Subject: ENERGY STAR[®] EVSE Draft 1 Specification and Draft 3 Test Method

The enclosed letter contains the California Investor Owned Utilities' (California IOUs) comments on the Draft 1 v1.0 Specification and Draft 3 v1.0 Test Method for the upcoming ENERGY STAR Electric Vehicle Service Equipment (EVSE) program. The California IOUs represent some of the largest utility companies in the western United States, serving a combined customer base of over 35 million people. The California IOUs include Pacific Gas and Electric Company (PG&E), Southern California Gas Company (SCGC), San Diego Gas and Electric (SDG&E), and Southern California Edison (SCE).

Attachment A – Relay Power Graphs

Figure 1 – Energy consumption (vertical axis) vs rated power (horizontal axis) for all reported EVSE

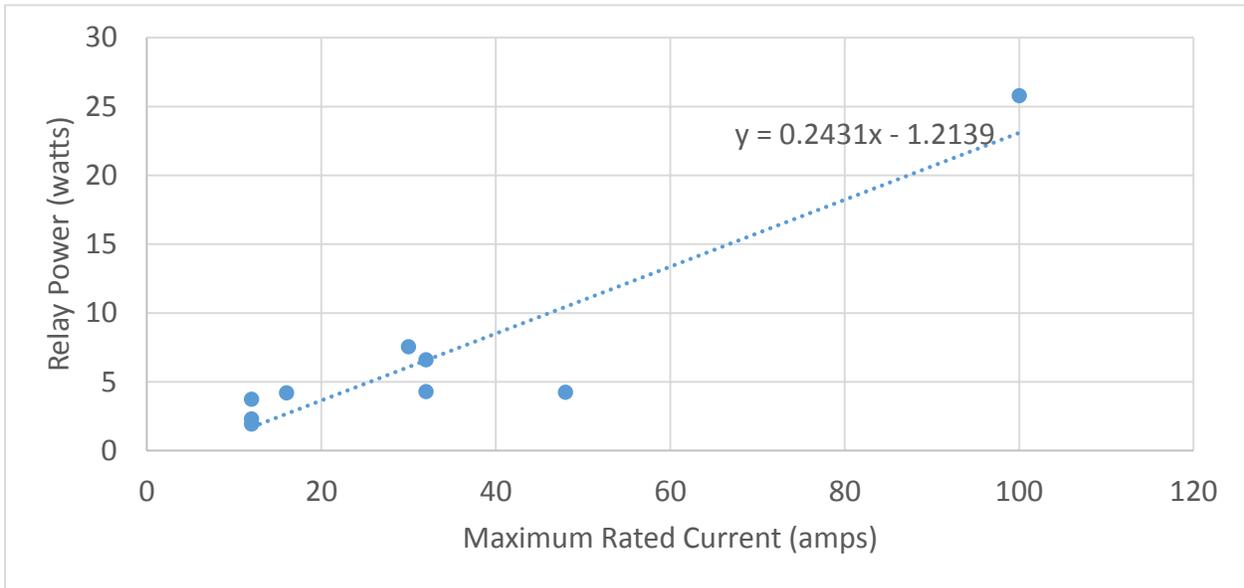
We understand that U.S. EPA added this allowance based on the expected power draw needed to close relay contacts and create a pathway for power flow from the EVSE to an electric vehicle (section 3.4 of the draft specification). We also understand that U.S. EPA originally calculated an allowance for relay power based on nine data points that aggregate all Level 1 and Level 2 products as well as one 100 ampere product that falls outside the scope of this proposed specification. These aggregated data points appeared to indicate that relay power would increase as a linear function of the unit's rated capacity. However, when we examined disaggregate data for Level 1 EVSE and then Level 2 EVSE we did not find any clear trend. These charts are shown in Appendix A. We also note that limited data is available, with four data points for Level 1 EVSE and four data points for Level 2 EVSE. Therefore, we encourage U.S. EPA to obtain additional data and recalculate the relay power

Figures 1, 2, and 3 below illustrate our comment regarding the relay power allowance in the draft specification. Figure 1 contains all products including the 100 amp outlier as shown in U.S. EPA’s spreadsheet, Figure 2 contains Level 1 EVSE, and Figure 3 contains Level 2 EVSE.
